APPLICATION NO.	FILING DATE	FIRST NAMED INVENTOR	ATTORNEY DOCKET NO.	CONFIRMATION NO.
10/797,441	03/09/2004	Michael Harty	D-1222 R2	4488
28995	7590	03/08/2007		
RALPH E. JOCKE walker & jocke LPA 231 SOUTH BROADWAY MEDINA, OH 44256			EXAMINER MCCLAIN, GERALD	
			ART UNIT	PAPER NUMBER
			3653	
SHORTENED STATUTORY PERIOD OF RESPONSE		MAIL DATE	DELIVERY MODE	
3 MONTHS		03/08/2007	PAPER

Office Action Summary

DETAILED ACTION

FIG. G1

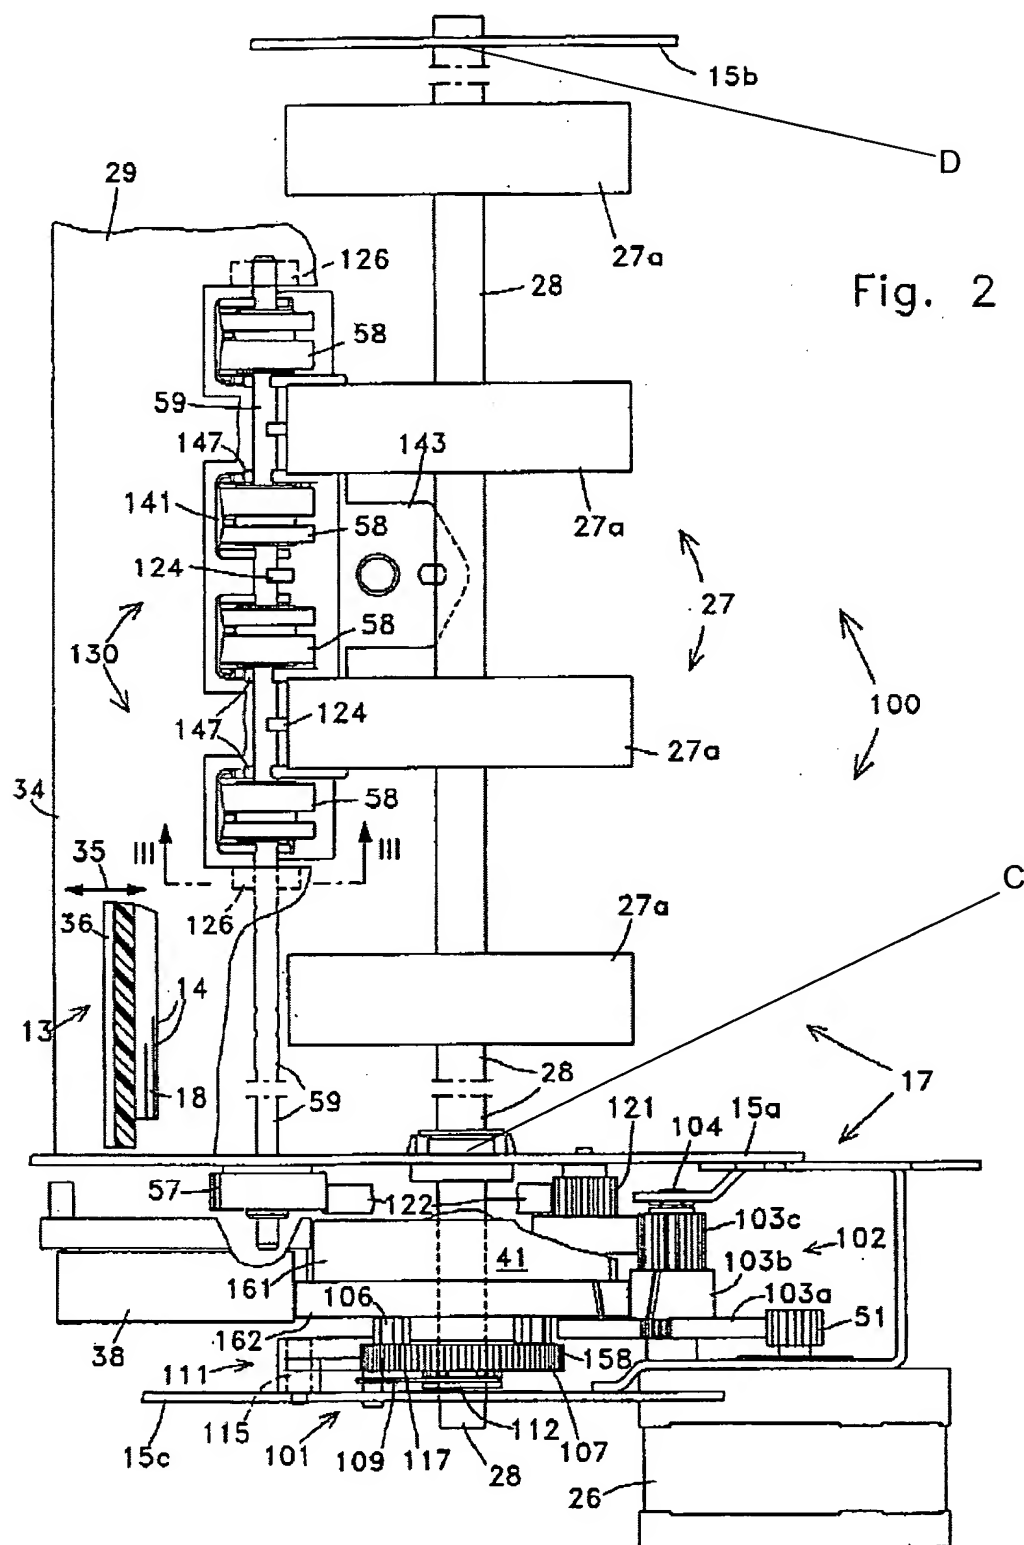
Claim 1: picker arrangement (100); automated banking machine media dispenser (column 1, lines 6-11); rotatable picker shaft (28); drive pin (110); picker roller (27); currency cassette (13); drive end (See Fig. 2, bottom end of 28); mating portion (See FIG. G1 below, C); opposite end (See FIG. G1 below, D); supporting member (15b);
